As an environmental Scientist, I appreciate the extensive efforts and labour that have been invested into the development of the Winterbourne Wind Farm Environmental Impact Statement.

I would like here to formalise an objection to the submission and will focus my objection specifically on what I see as significant risks to the natural environment and biodiversity within and around the outlined project boundary.

Figure 1 New England Bio diversity region

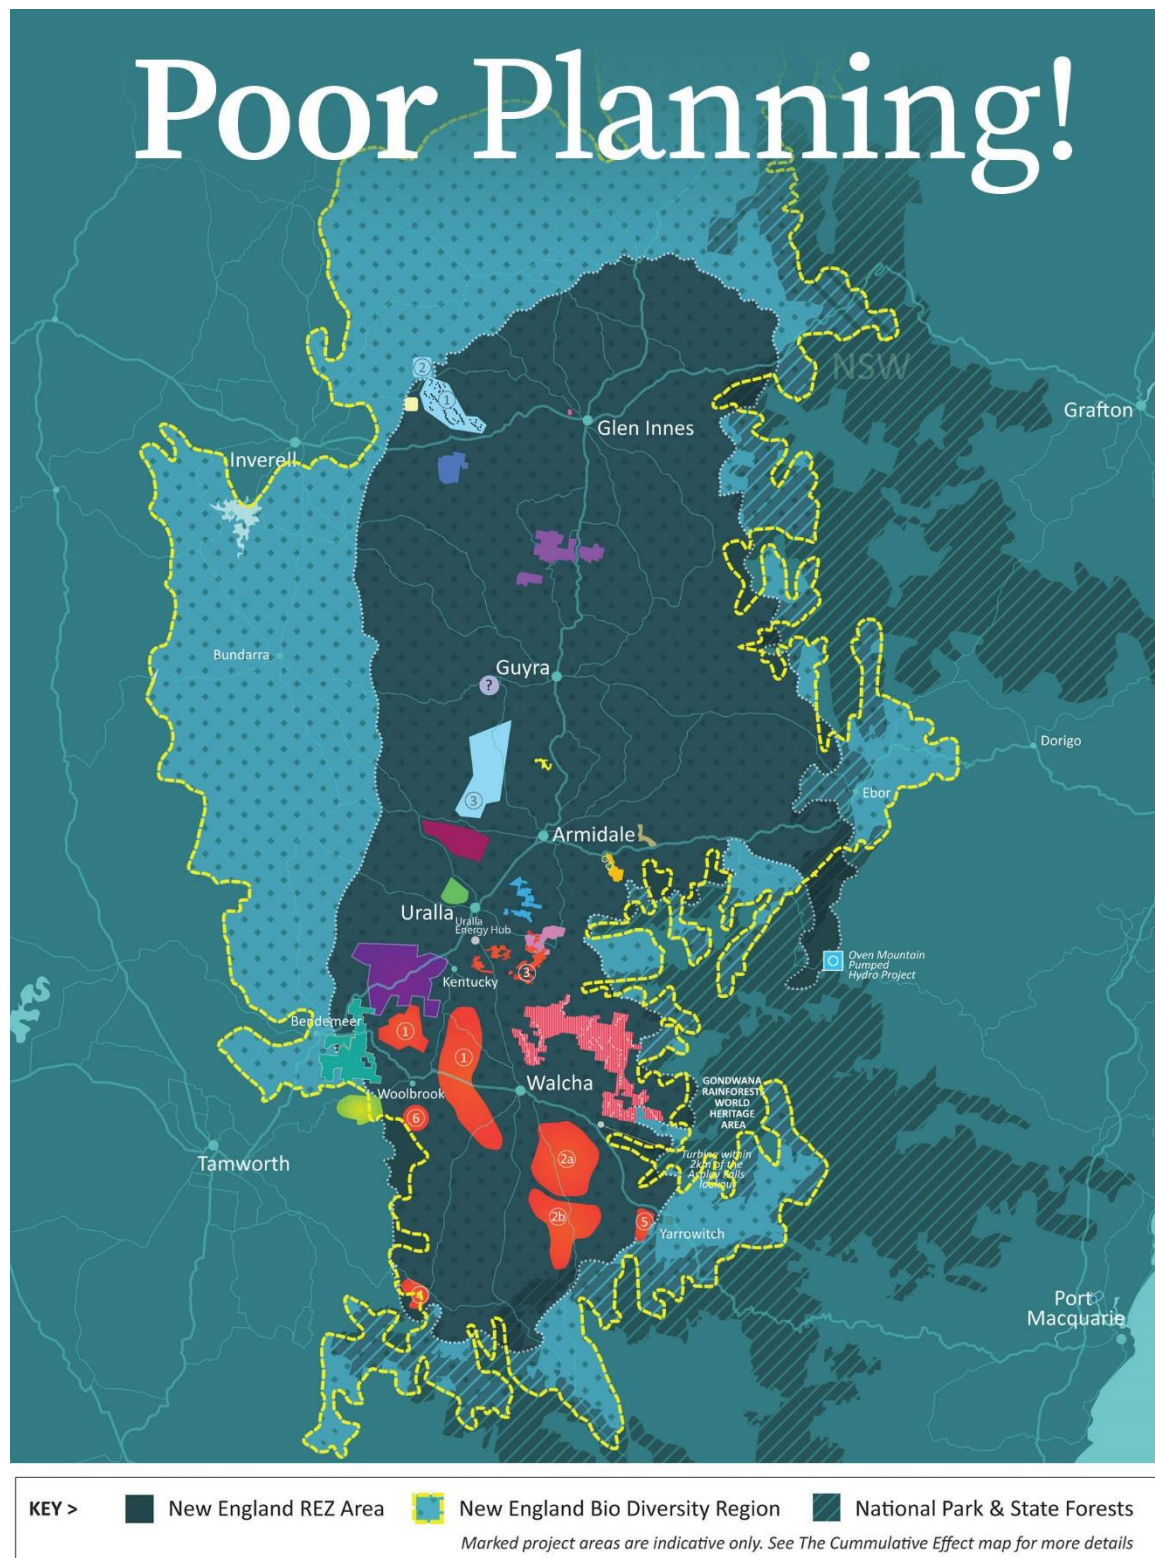
Would these ‘Linking habitats’ not include areas outside of the REZ but within the boundary of New England Bio Diversity region? (See figure 1 below).

Figure 5 bionet map showing locations of wedge tail. needle tail and little eagle within footprint

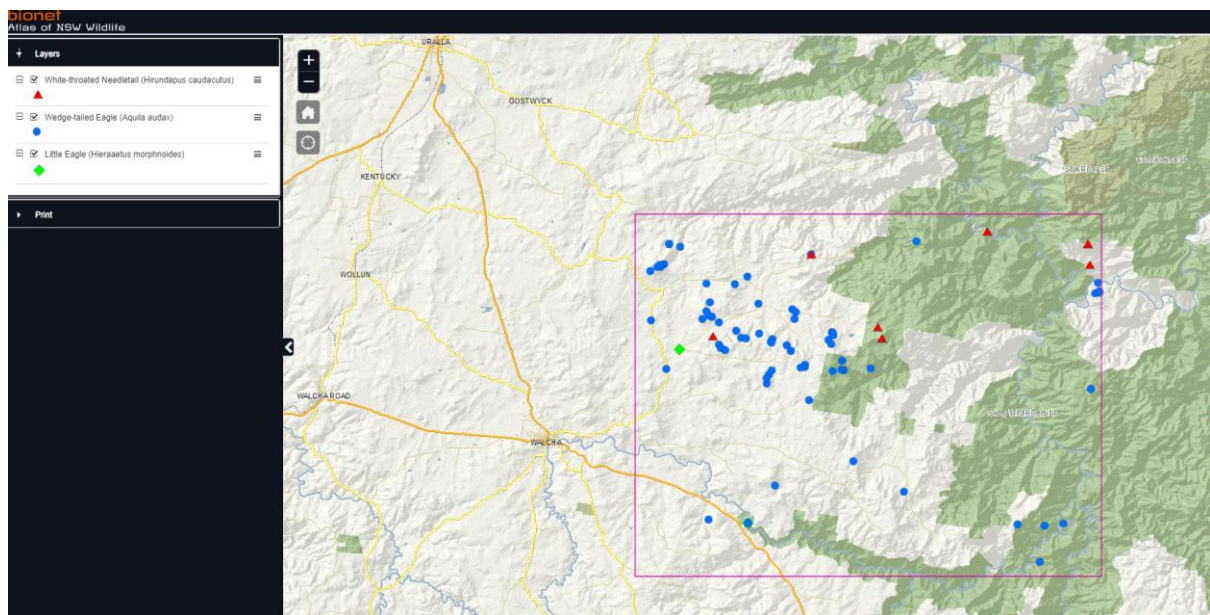
flies all day it is going to pass many wind farms and many wind turbines and risk being killed. The White-throated Needletail is considered 'vulnerable' by the government of Australia (Commonwealth status). According to the NSW Office of Environment and Heritage, the WTN is migratory and usually seen in Eastern Australia from October to April. With regards to their regional distribution and habitat (according to OEH) the WTN is known to be predicted within the new England Tablelands Interim biogeographic regionalisation, particularly with respect to the Winterbourne footprint near Walcha Plateau and also the Yarrowyck -Kentucky Downs. As mentioned in appendix G which viewed the NSW Bionet atlas in Jan 2022, the WTN does indeed populate the area in question as does two other bird species listed as 'identified as having moderate risk associated with a collision with turbine blades during the operation of the Project; the wedge tail eagle and the little eagle which is listed as threatened (see figure 5).
